ADDENDUM NO. 3 - REVISED
CLASSROOM ADDITION TO LINCOLN HIGH SCHOOL
Architect Job No. 22-20
March 09, 2023
DCM # 2023129
Bid Number 1745

The Plans and Specifications are hereby amended. The following supersedes all contrary and/or conflicting information and is made part of the contract documents.

PROJECT: CLASSROOM ADDITION TO LINCOLN HIGH SCHOOL	PROJECT NO. 22-20	REFERENCE: ADDENDUM #3
ARCHITECTURAL SUPPLEMENTAL DRAWING A2.1 - MAIN LEVEL FLOOR PLAN	DATE: 3-1-23	SHEET NO. ASD 3.1

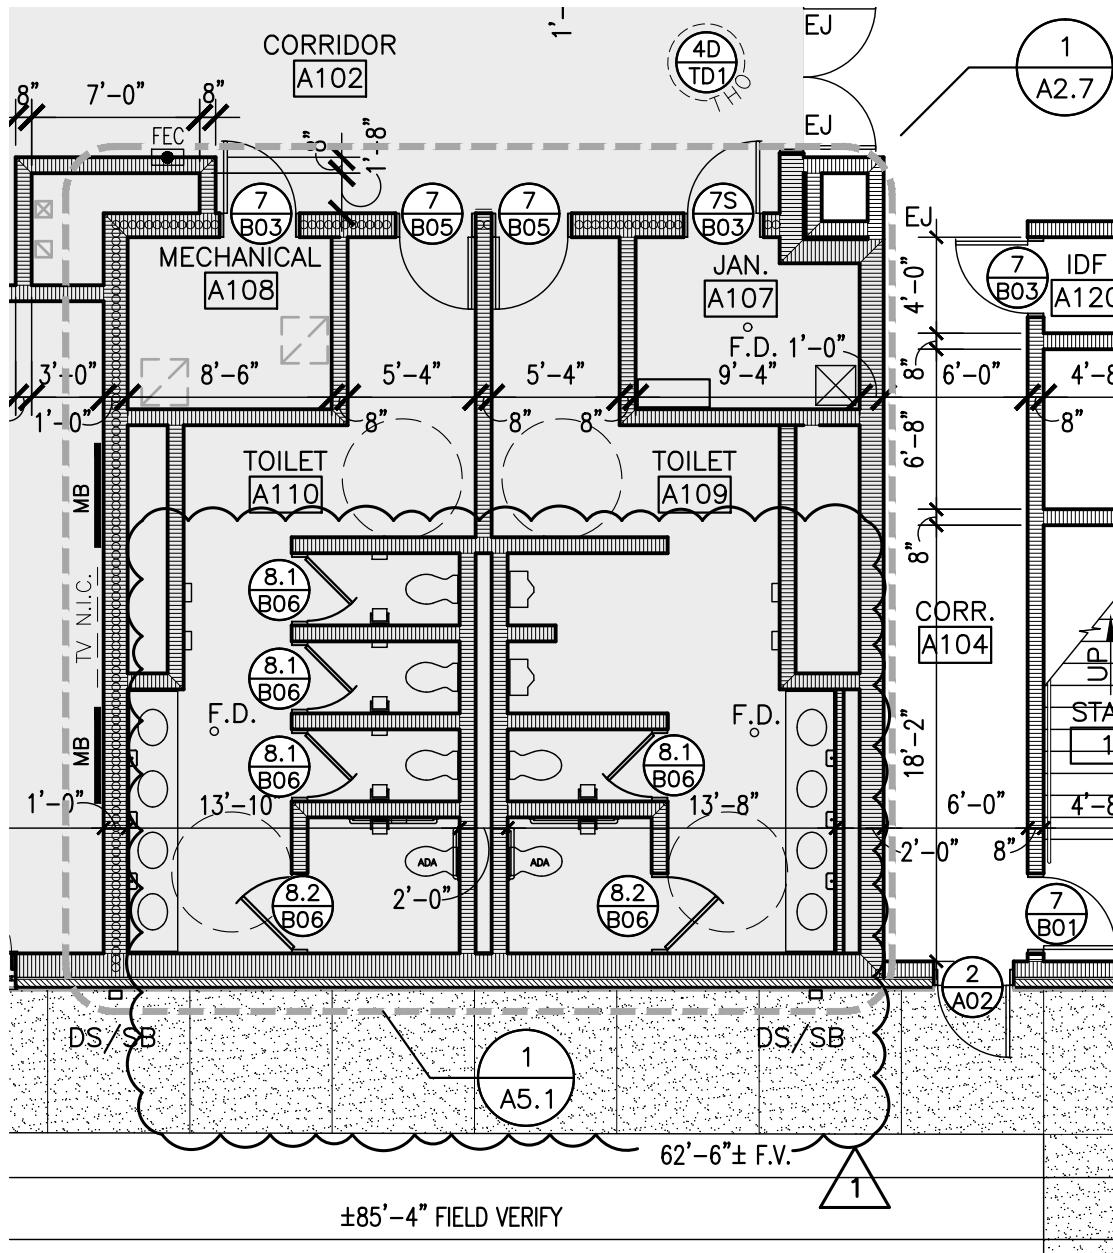
1. See attached **ASD 3.1** – added a plumbing chase behind the sinks in A109.
2. See attached **ASD 3.2** – added a plumbing chase in classroom A112 and made the chase larger at the entrance to classroom A112 and A113.

SHEET NO.
ASD 3.3

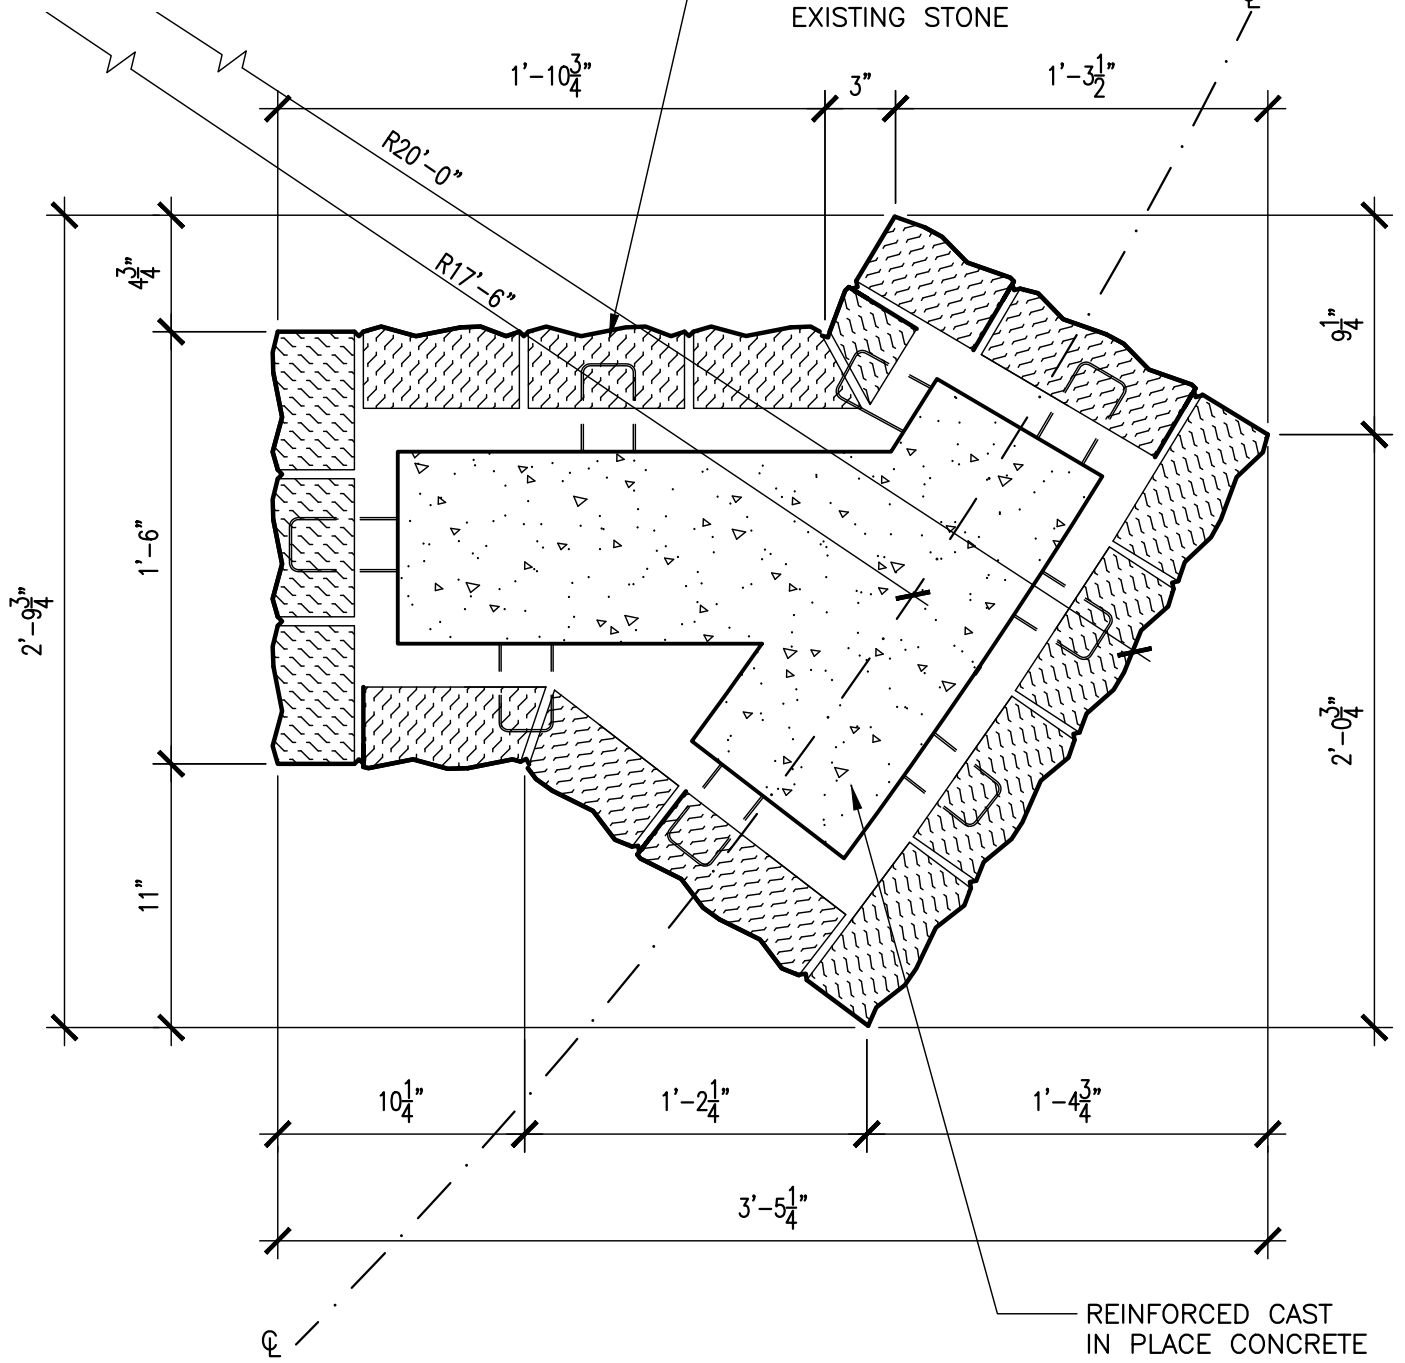
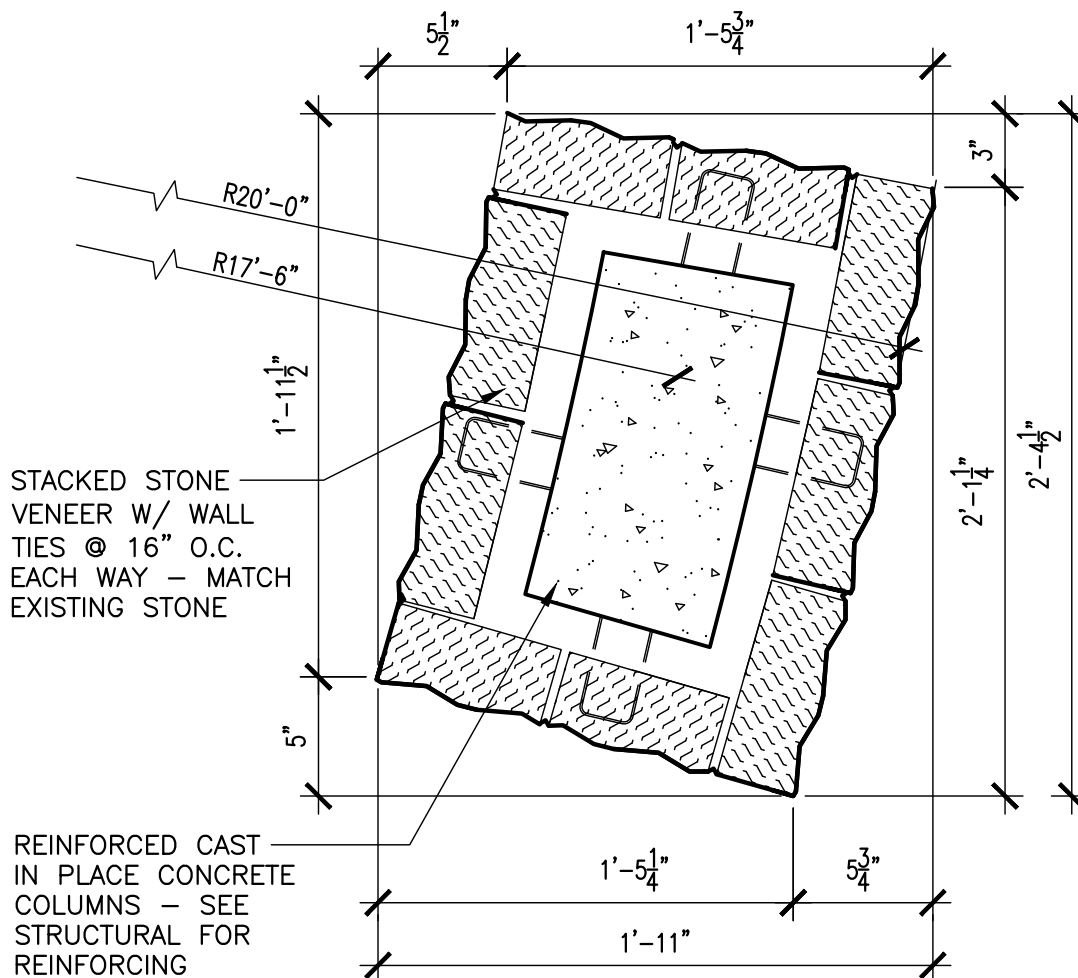
3. See attached **ASD 3.3 and ASD 3.4** – modified to plan details.
4. See attached **ASD 3.5** – modified punch out panel framing.
5. See attached **ASD 3.6** – modified wall section #3.

SHEET TITLE:
MECHANICAL FLOOR PLAN

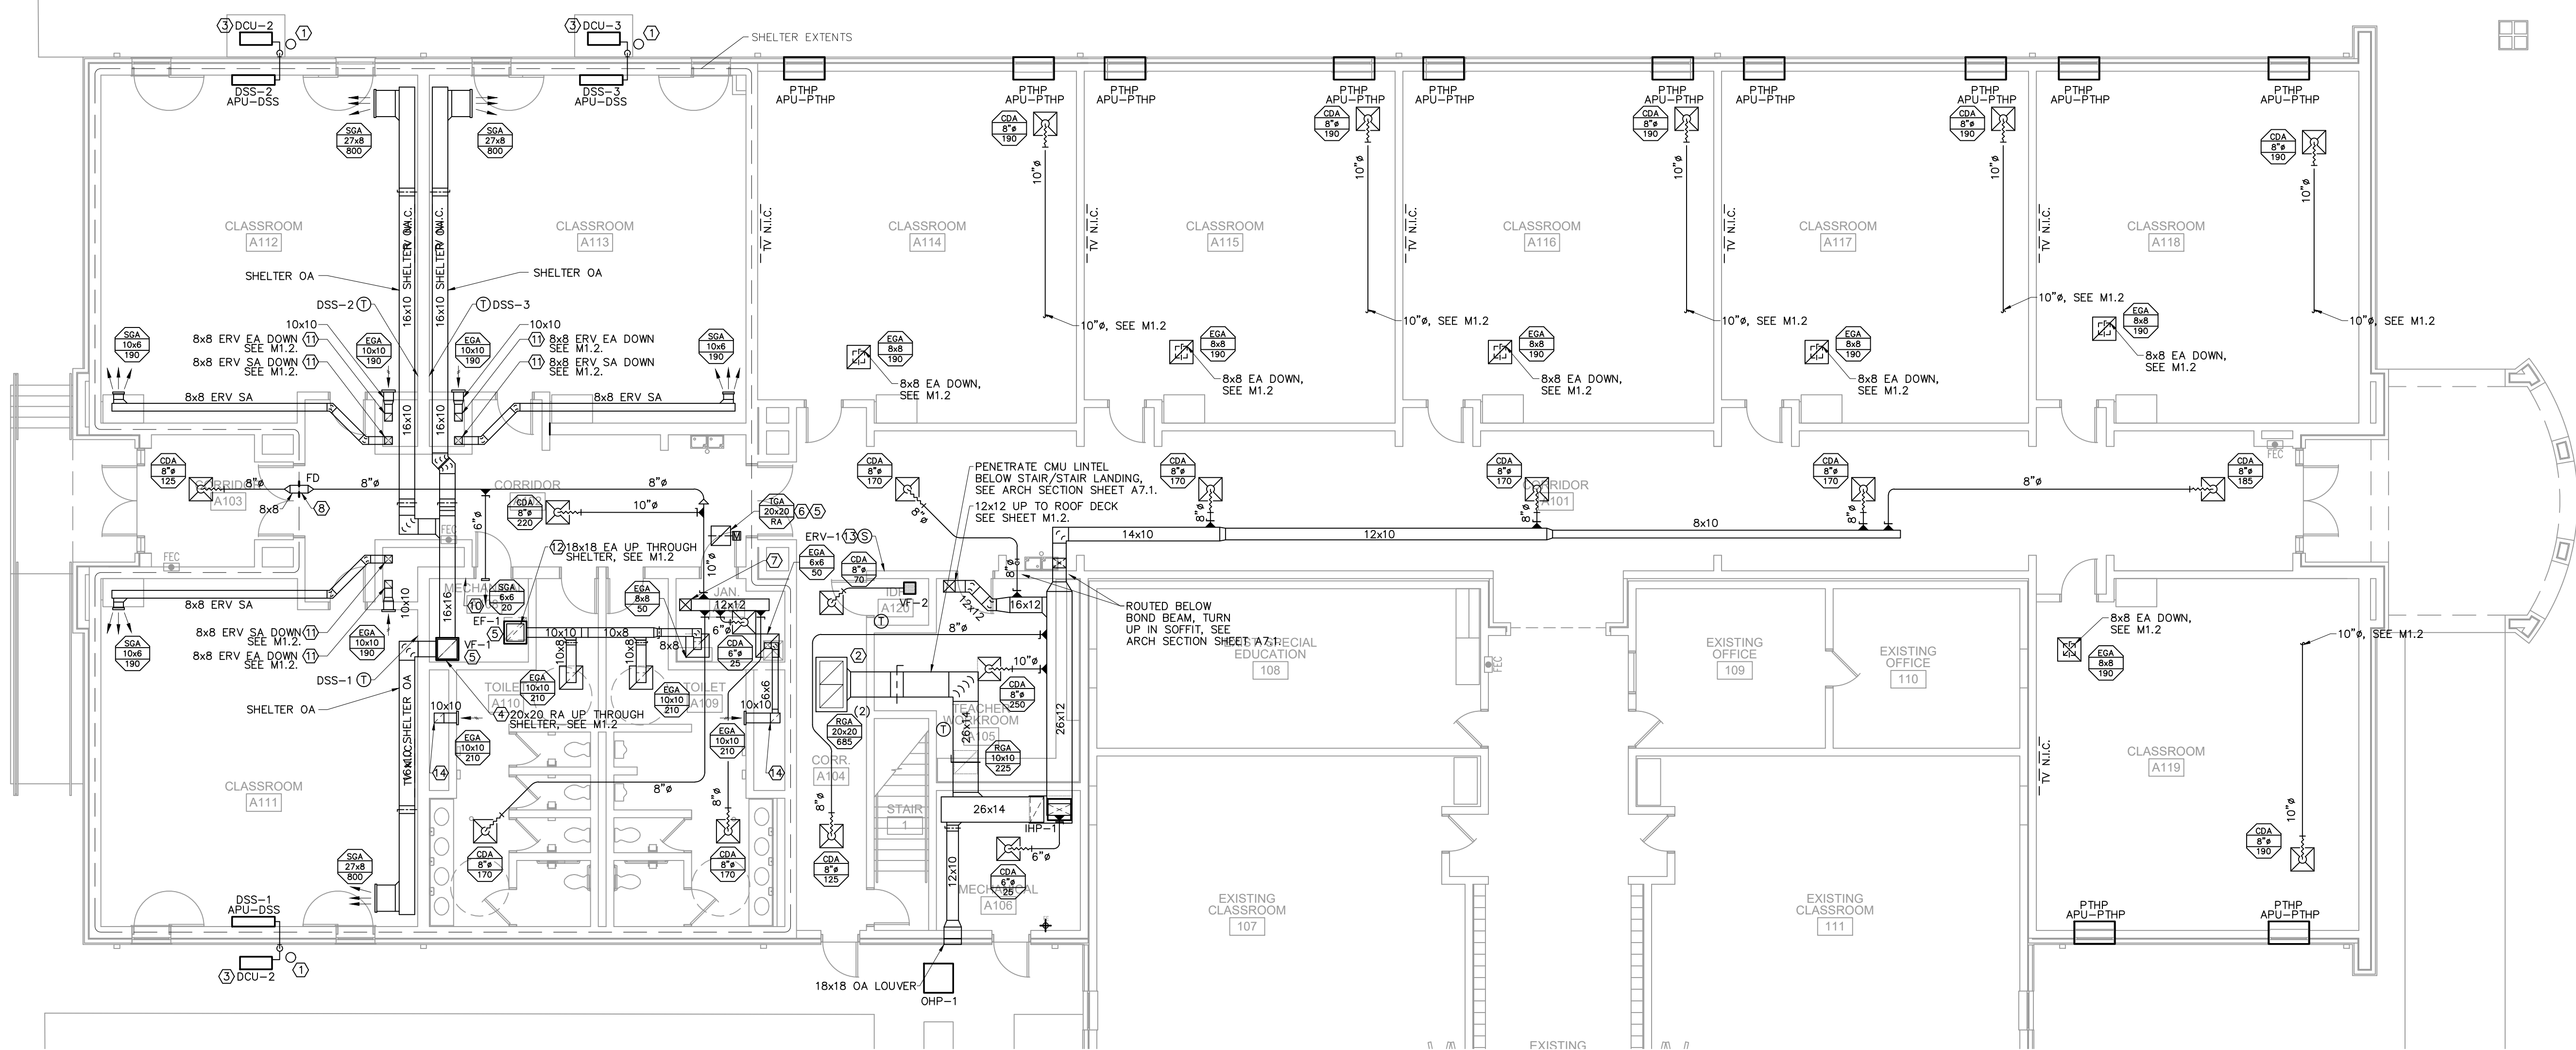
6. See attached **ASD 3.7** – modified reflected ceiling system.
7. See attached **M0.1, M1.1, M1.2, M1.3, M2.1, M2.2, M2.3** – for coordination revisions and state comments addressed.

P1.1

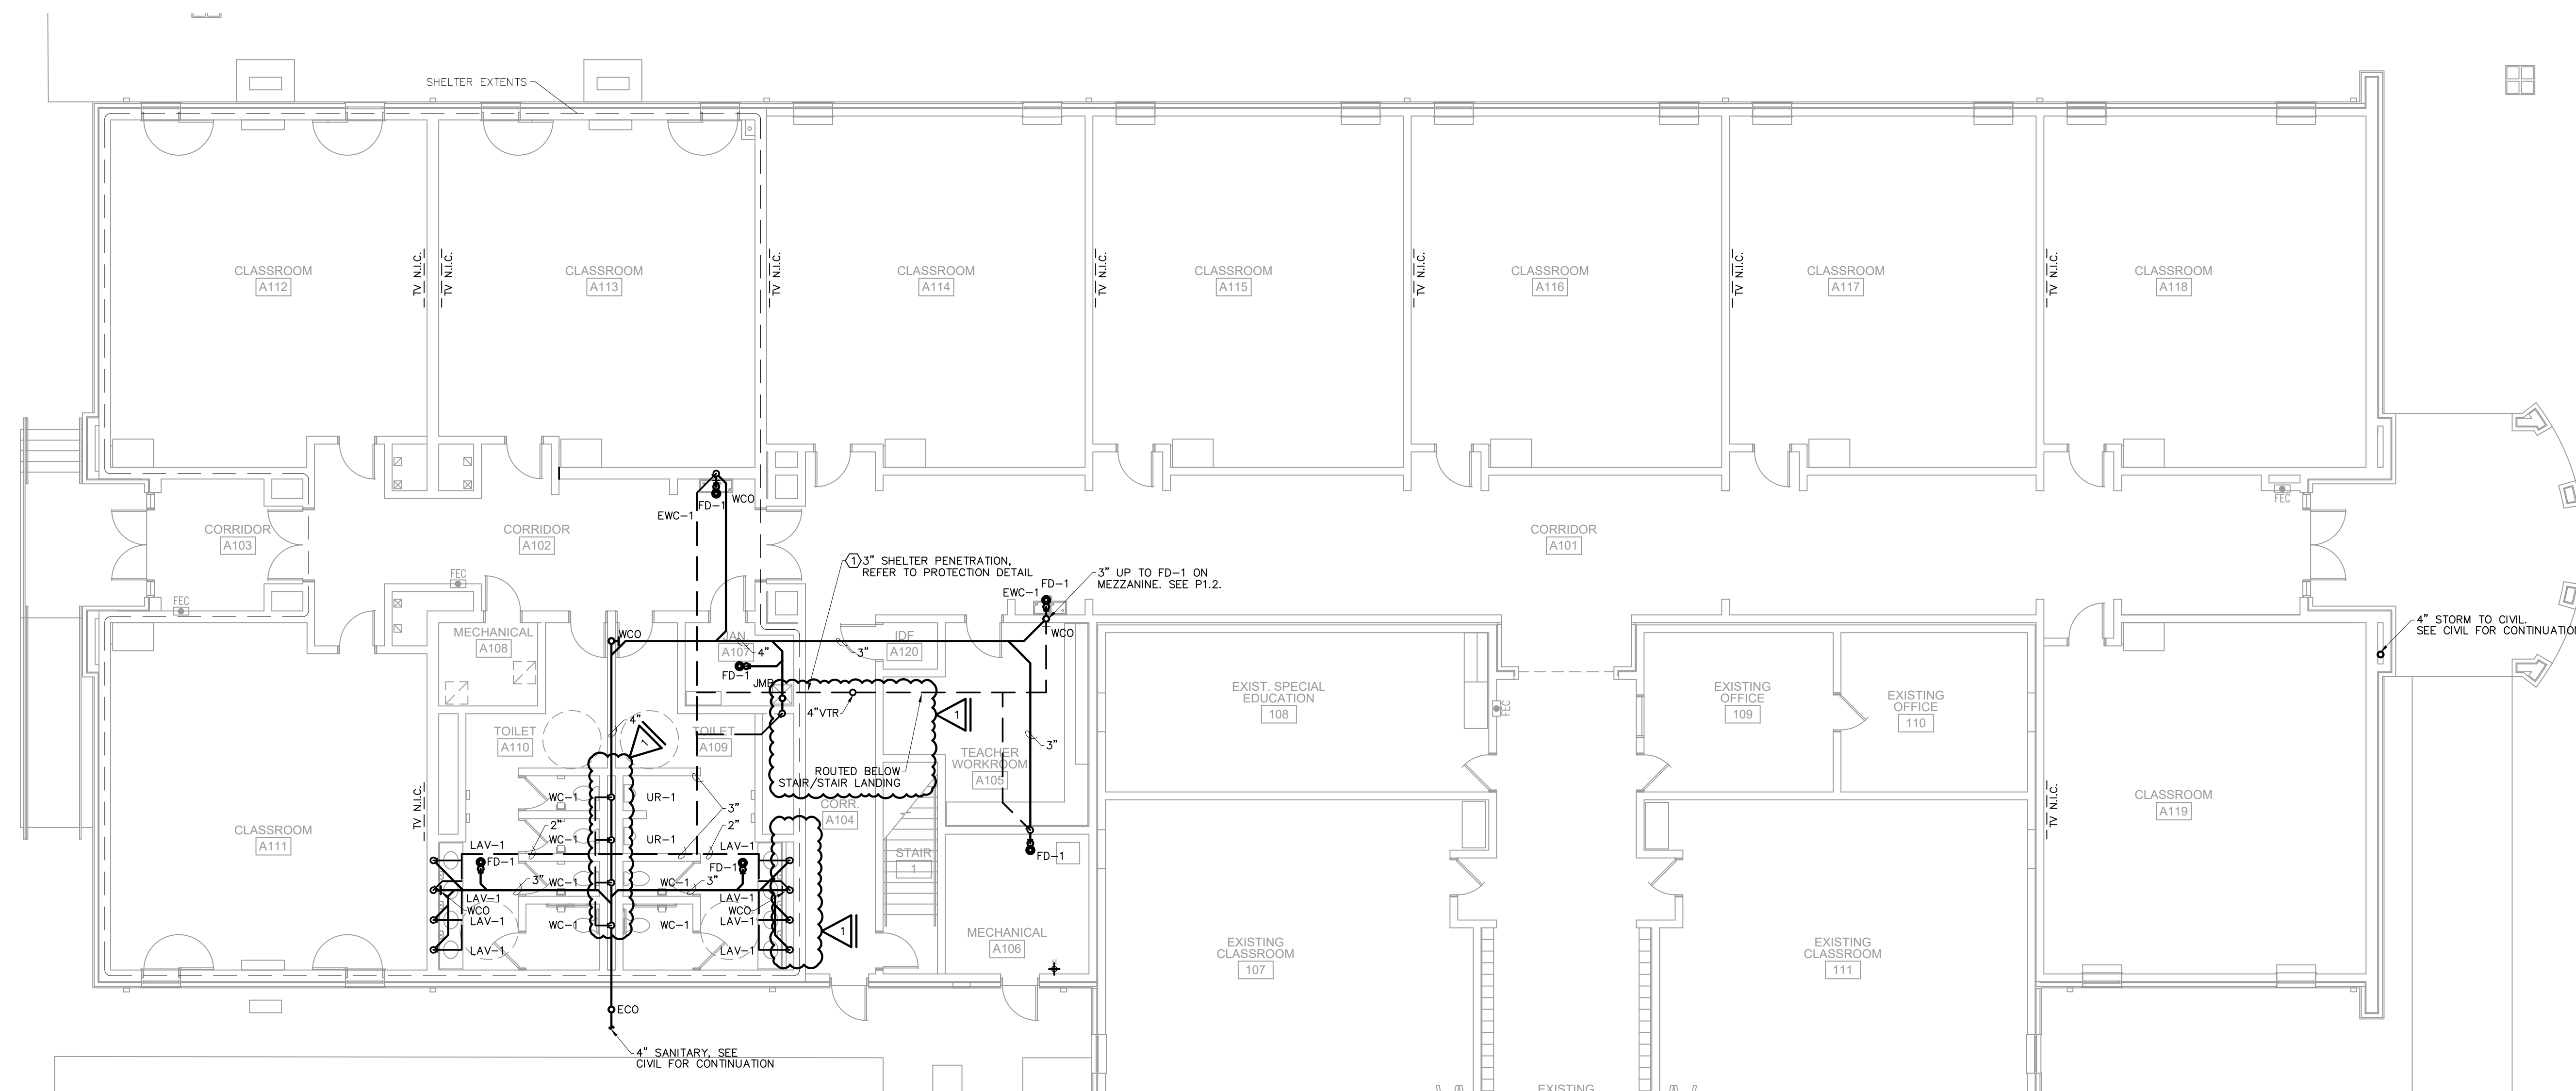
8. **P1.1, and P2.1** – for coordination revisions.
9. See attached **Sheet S1.0** – Steel allowance quantities in General Notes 7.18 & 7.19 have been revised based on quantities noted/stated in the project specifications.
